Town of Hilton Head Island Regular Design Review Board Meeting

February 9, 2016

AGENDA

SITE PLAN

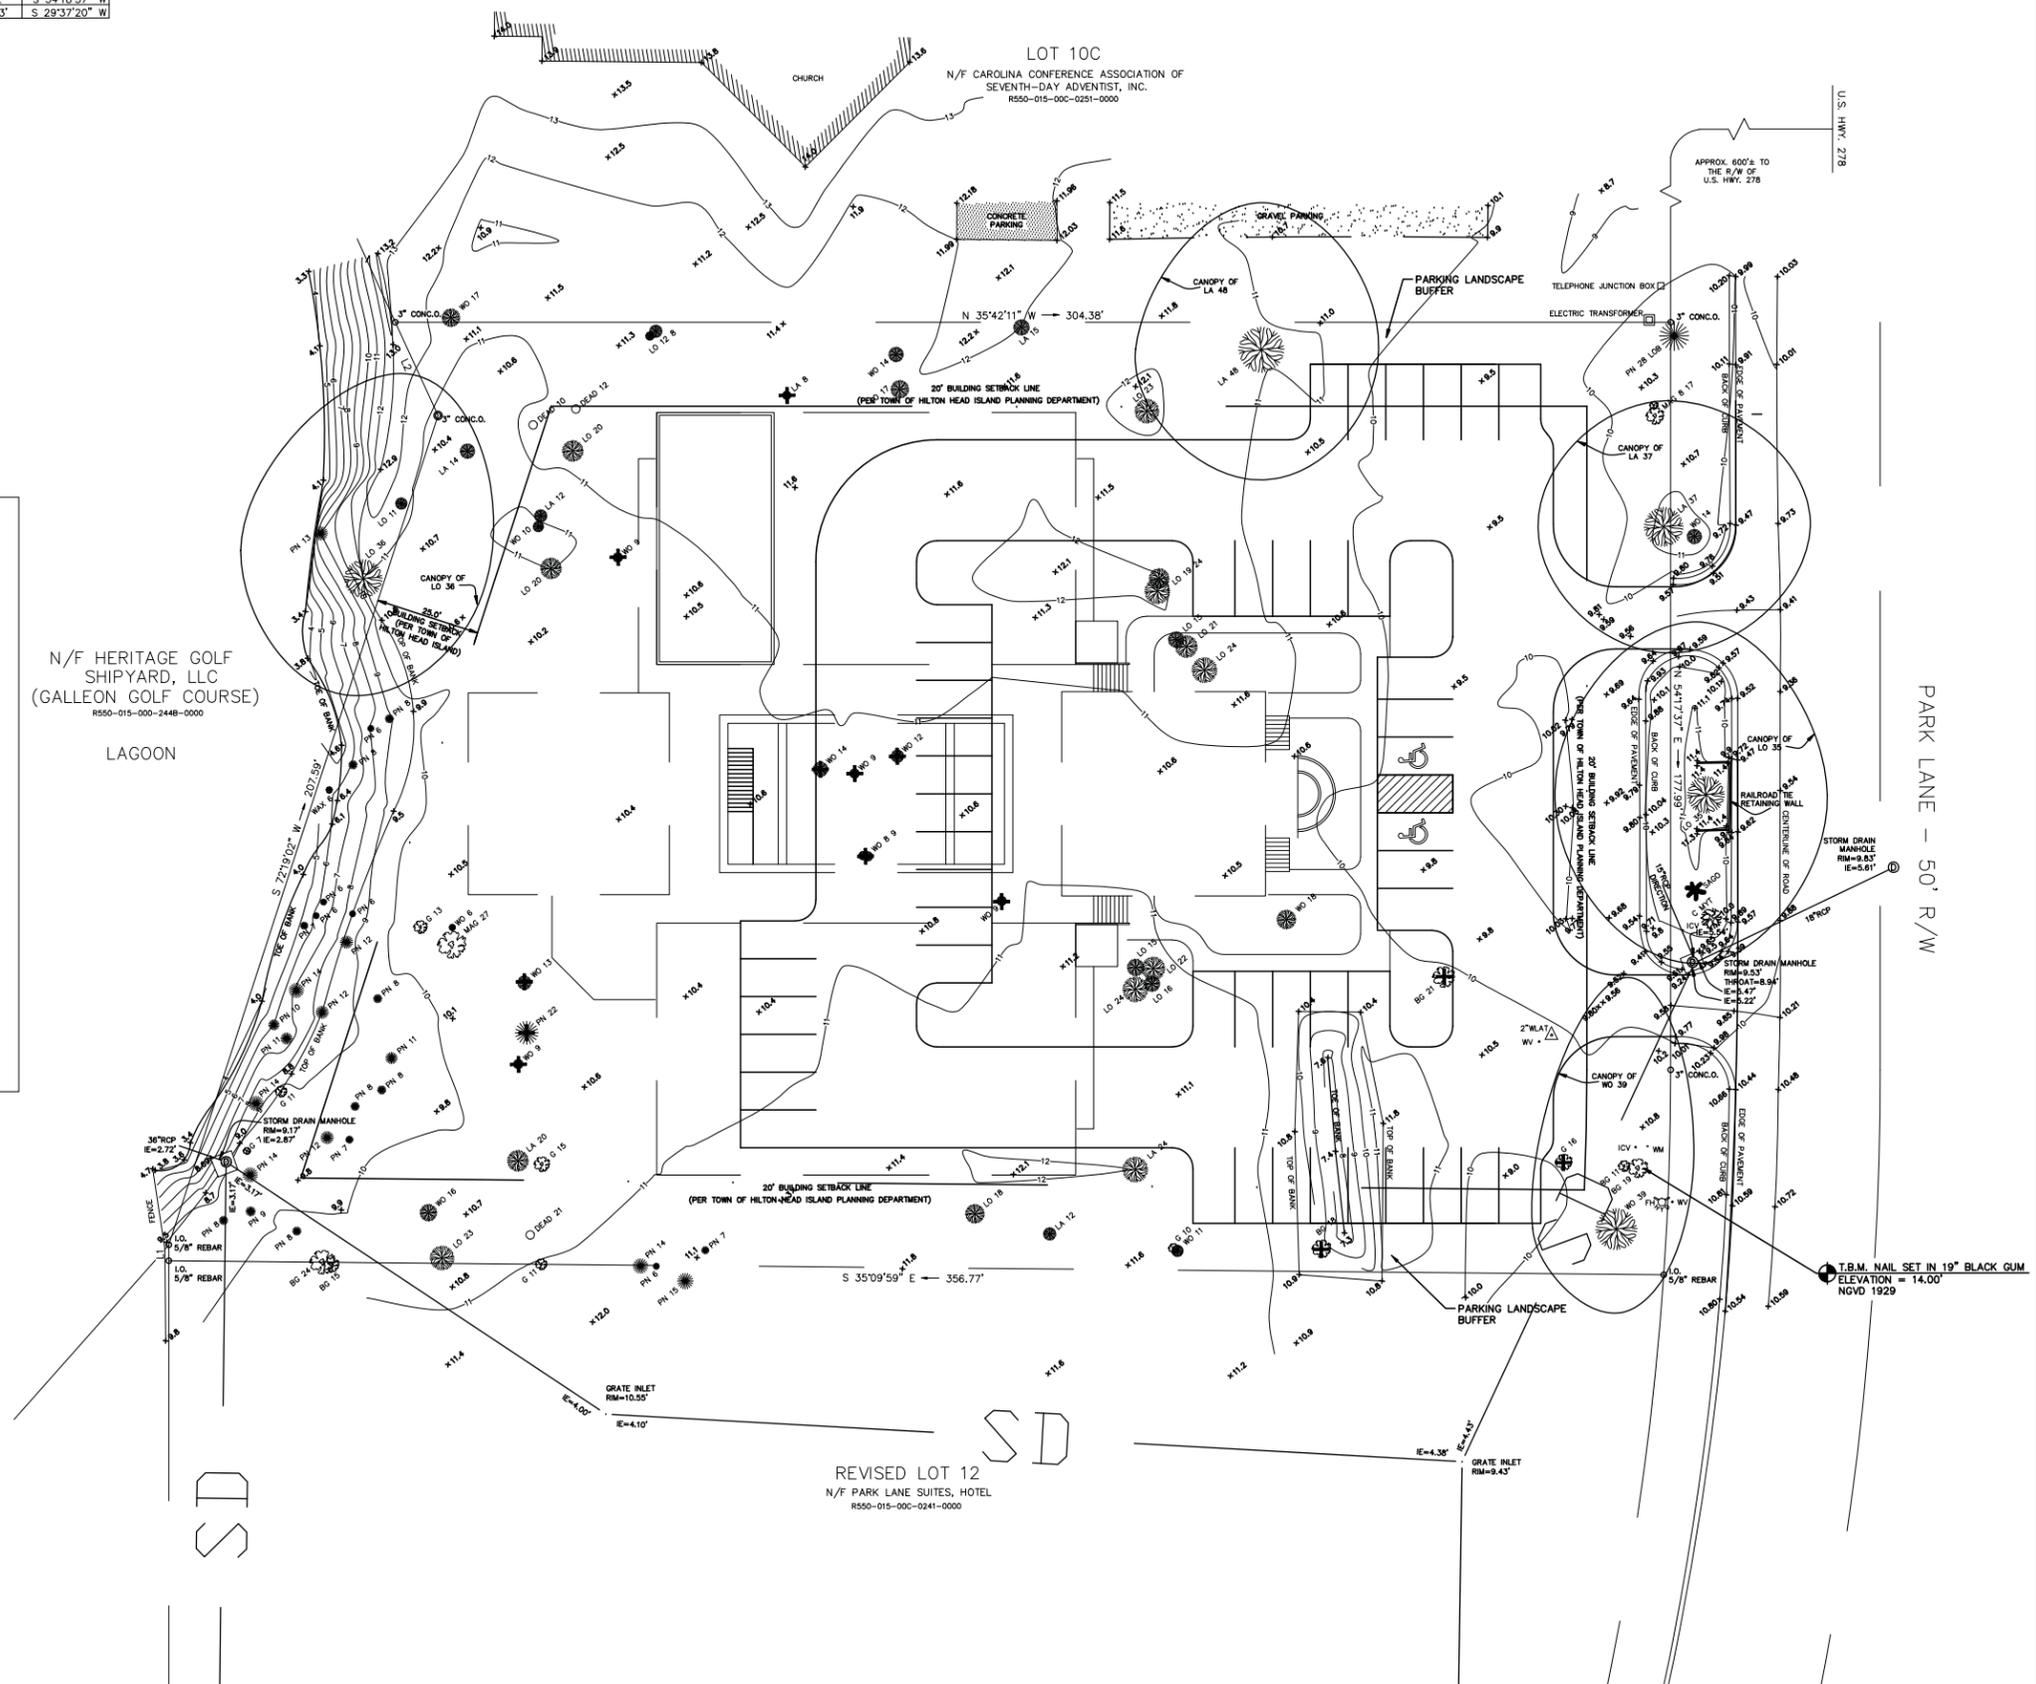
1. Significant landscaping (large scale materials) should be planted to balance mass of building over parking.
2. Specimen trees at entrance appear to be heavily under-planted. Refer to LMO requirements regarding impact under canopy of specimen trees.
3. Reconsider use of ferns under building with little/no sunlight.

A variety of species is selected for texture and color	<input type="checkbox"/>	<input type="checkbox"/>	<input checked="" type="checkbox"/>	Full landscape plan including plant schedule required for Final submittal.
Provides overall order and continuity of the Landscape plan	<input checked="" type="checkbox"/>	<input type="checkbox"/>	<input type="checkbox"/>	
Native plants or plants that have historically been prevalent on the Island are utilized	<input type="checkbox"/>	<input type="checkbox"/>	<input checked="" type="checkbox"/>	
A variety of sizes is selected to create a “layered” appearance for visual interest and a sense of depth	<input checked="" type="checkbox"/>	<input type="checkbox"/>	<input type="checkbox"/>	
The location of existing mature trees is taken into account in placement of shrubs so as not to damage tree roots	<input checked="" type="checkbox"/>	<input checked="" type="checkbox"/>	<input type="checkbox"/>	Specimen trees at entrance appear to be heavily under-planted. Refer to LMO requirements regarding impact under canopy of specimen trees.

ELEVATIONS

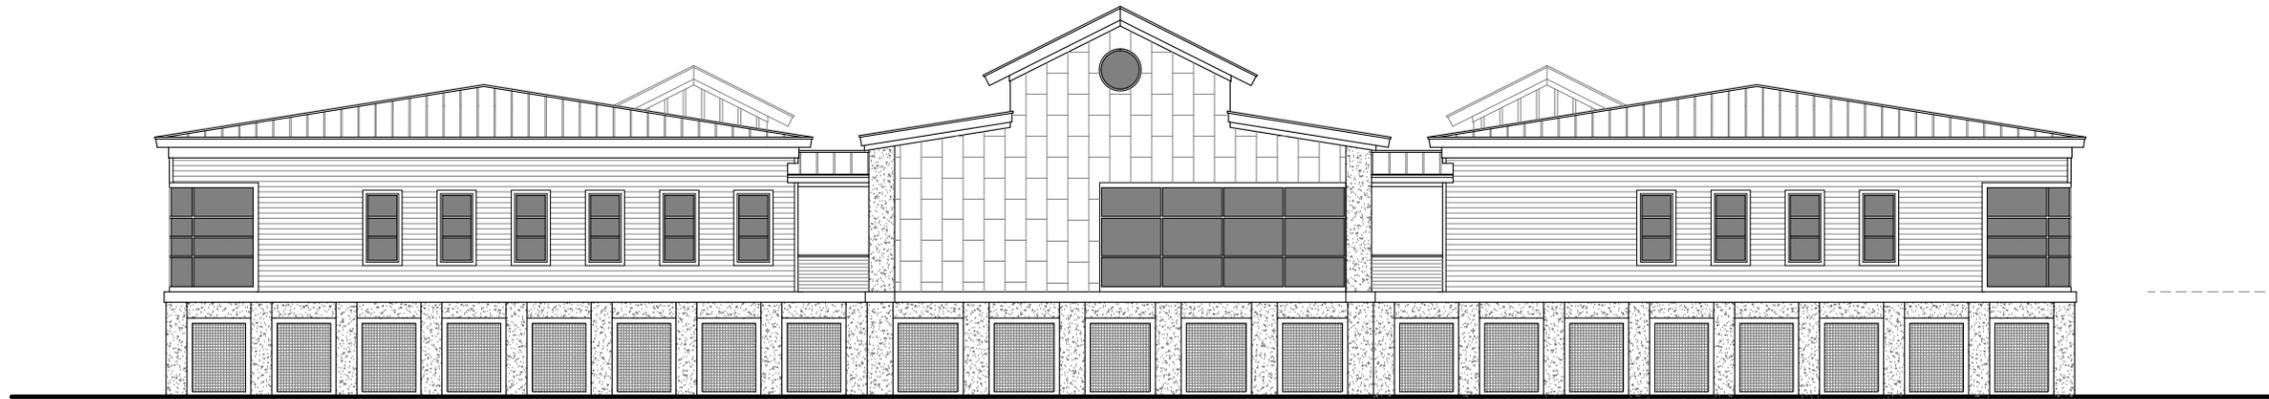
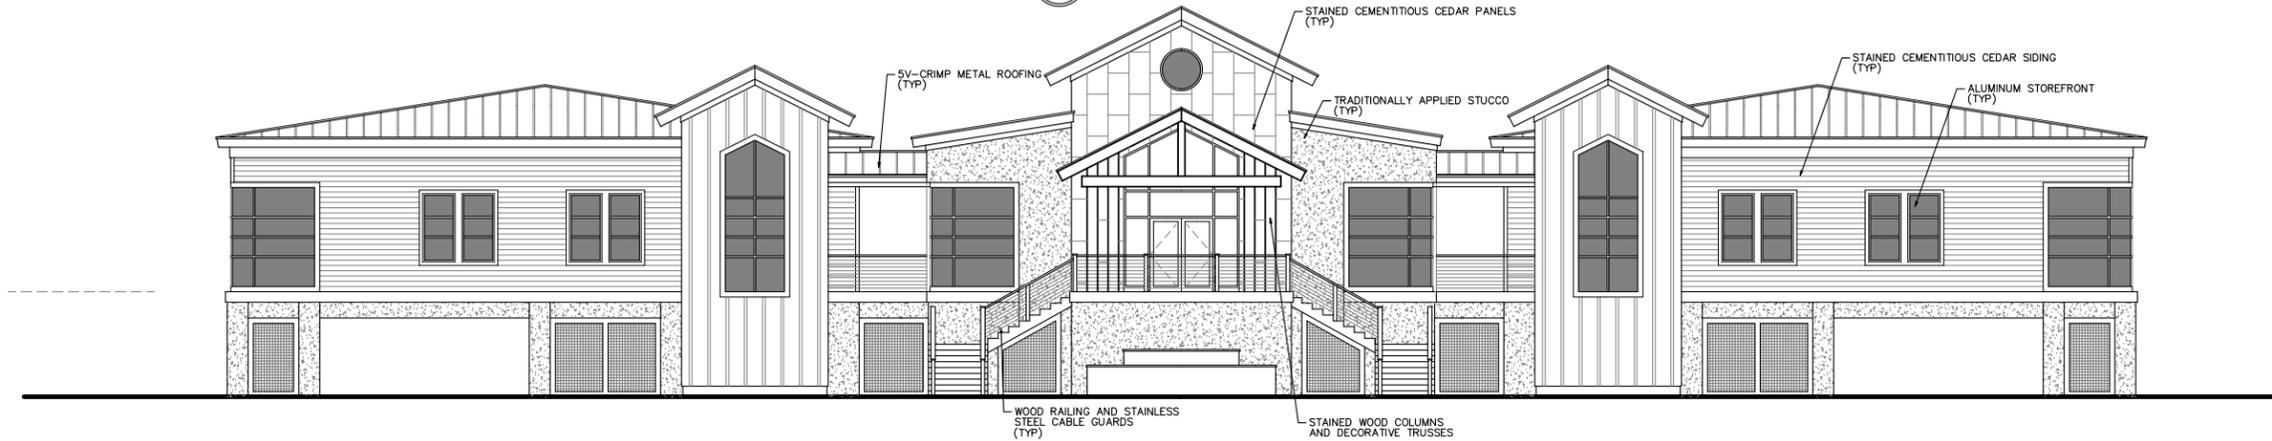
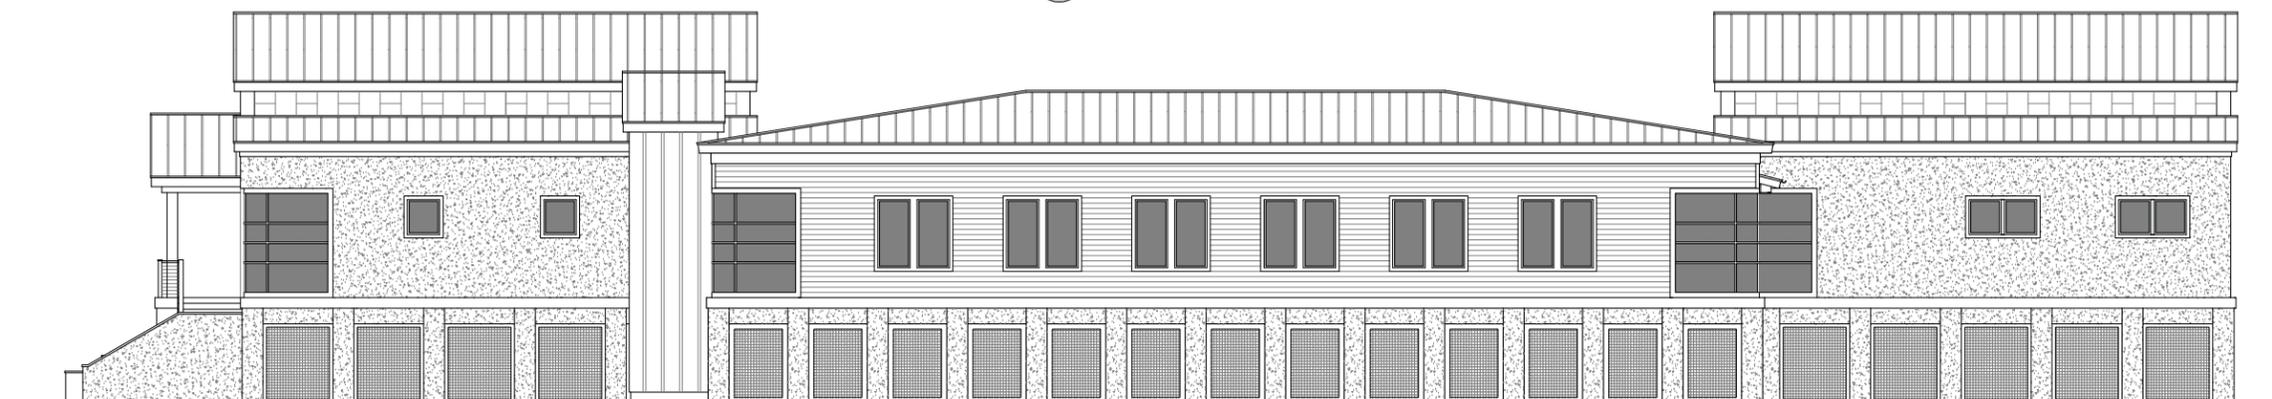
Has a strong roof form with enough variety to provide visual interest	<input checked="" type="checkbox"/>	<input type="checkbox"/>	<input type="checkbox"/>	Flat roof has been replaced with pitched roof per the Design Guide.
Minimum roof pitch of 6/12	<input type="checkbox"/>	<input type="checkbox"/>	<input type="checkbox"/>	Not specified.
Overhangs are sufficient for the façade height.	<input checked="" type="checkbox"/>	<input type="checkbox"/>	<input type="checkbox"/>	Overhangs have been added/increased.
Forms and details are sufficient to reduce the mass of the structure	<input checked="" type="checkbox"/>	<input type="checkbox"/>	<input type="checkbox"/>	
Human scale is achieved by the use of proper proportions and architectural elements	<input checked="" type="checkbox"/>	<input type="checkbox"/>	<input type="checkbox"/>	
Utilizes a variety of materials, textures and colors	<input checked="" type="checkbox"/>	<input type="checkbox"/>	<input type="checkbox"/>	“Earthy colors”; tabby, cementitious cedar siding, decking, metal roofs, and cementitious vertical cedar panels
